HISTORIC AND DESIGN REVIEW COMMISSION

June 16, 2021

HDRC CASE NO: 2021-261
ADDRESS: 354 CLUB DR
LEGAL DESCRIPTION: NCB 6703 BLK 13 LOT 24 & E 25 FT OF 23
ZONING: R-6, H
CITY COUNCIL DIST.: 7
DISTRICT: Monticello Park Historic District
APPLICANT: Marcia Moore/MOORE MARCIA
OWNER: Marcia Moore/MOORE MARCIA
TYPE OF WORK: Driveway modifications
APPLICATION RECEIVED: May 18, 2021
60-DAY REVIEW: Not applicable due to City Council Emergency Orders
CASE MANAGER: Rachel Rettaliata

The applicant is requesting a Certificate of Appropriateness for approval to widen the existing ribbon driveway.

EXISTING LAYOUT
 DRIVEWAY APPROACH
 354 CLUB DR.

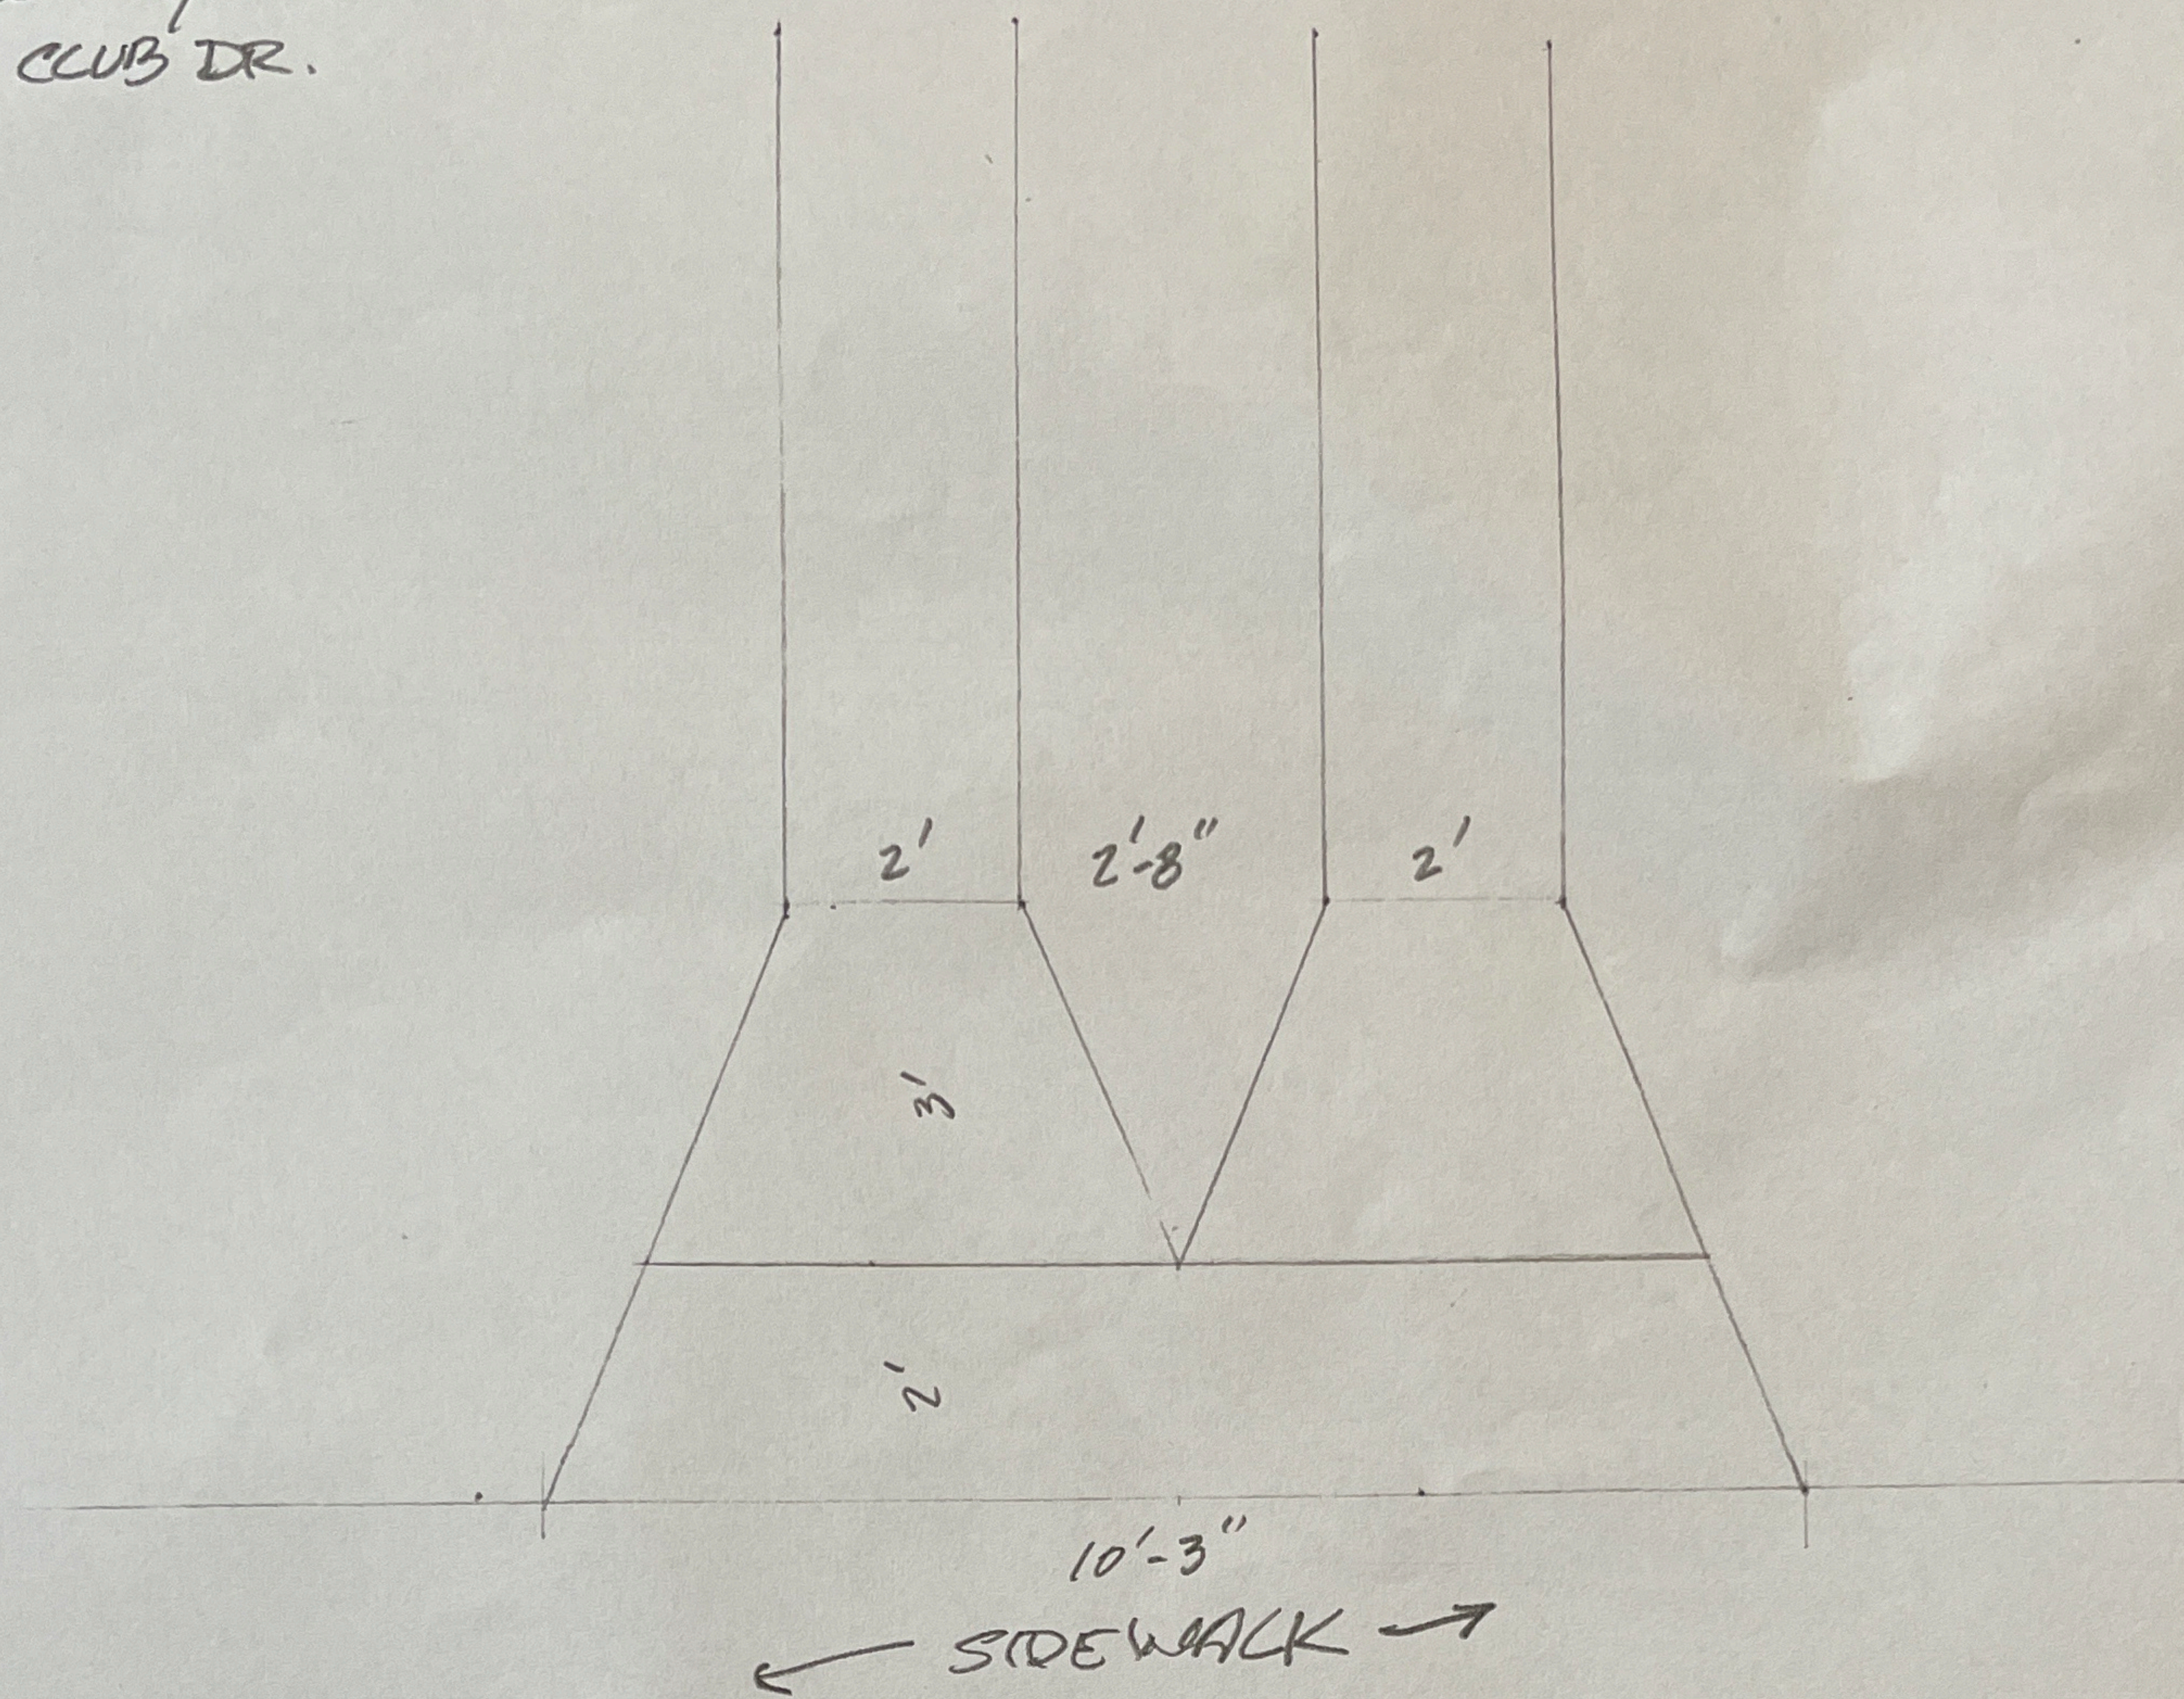
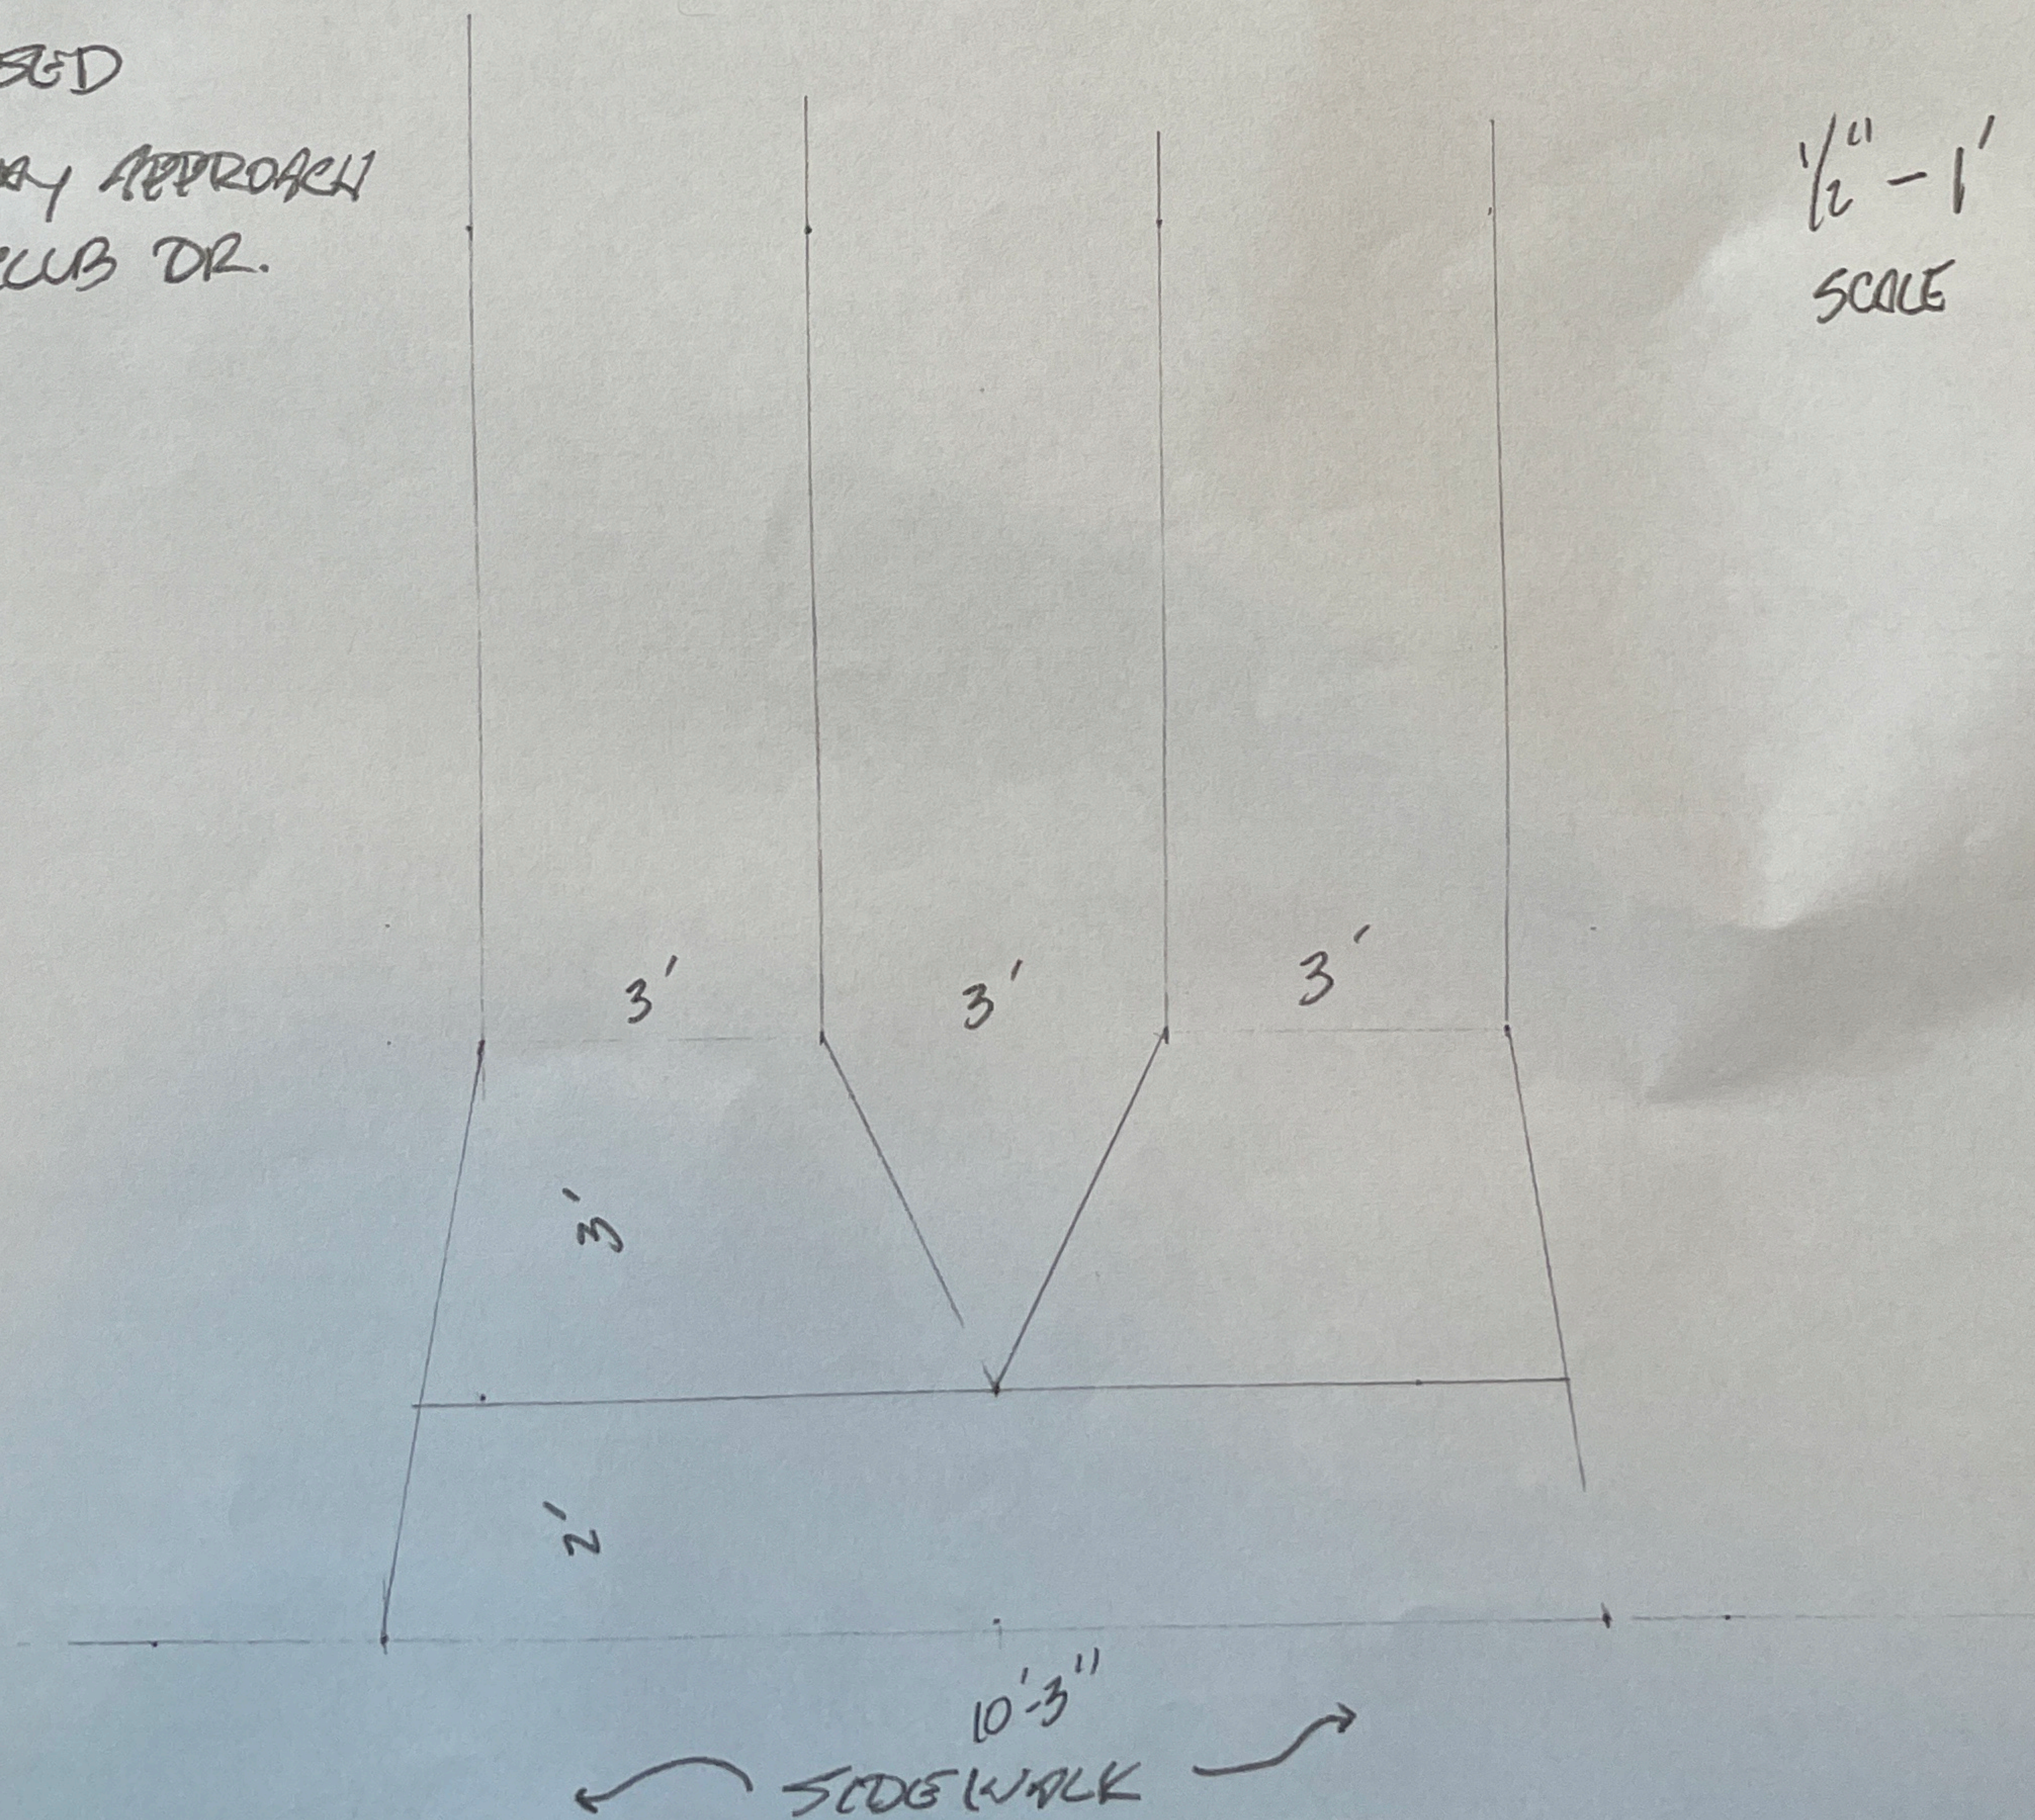
- a. The primary structure located at 354 Club is a 2-story, single-family structure constructed circa 1940. The residence features a red clay tile hip roof, stone cladding, a recessed front entry, one-over-one and divided lite windows, and a ribbon driveway. The property is contributing to the Monticello Park Historic District.
- b. **DRIVEWAY MODIFICATIONS** – The applicant has proposed to repair the existing concrete ribbon driveway and widen the existing ribbons from 2 feet to 3 feet in width. According to Guideline 5.B.i for Site Elements, historic driveway configurations should be retained and repaired in place. Incorporate a similar driveway

configuration—materials, width, and design—to that historically found on the site. Historic driveways are typically no wider than 10 feet. Pervious paving surfaces may be considered where replacement is necessary to increase stormwater infiltration. The applicant has expressed that the streetscape along club features both historic ribbon driveways and fully concrete driveway and has provided evidence that the neighboring property features 3-foot-wide driveway ribbons. The applicant would like to install driveway ribbons to match the width of the adjacent driveway. Staff finds that the proposal to widen each ribbon by one (1) foot in order to create a functional driveway and retain the historic configuration and material appropriate and consistent with the Guidelines.

Staff recommends approval of the driveway modification based on findings a through b.
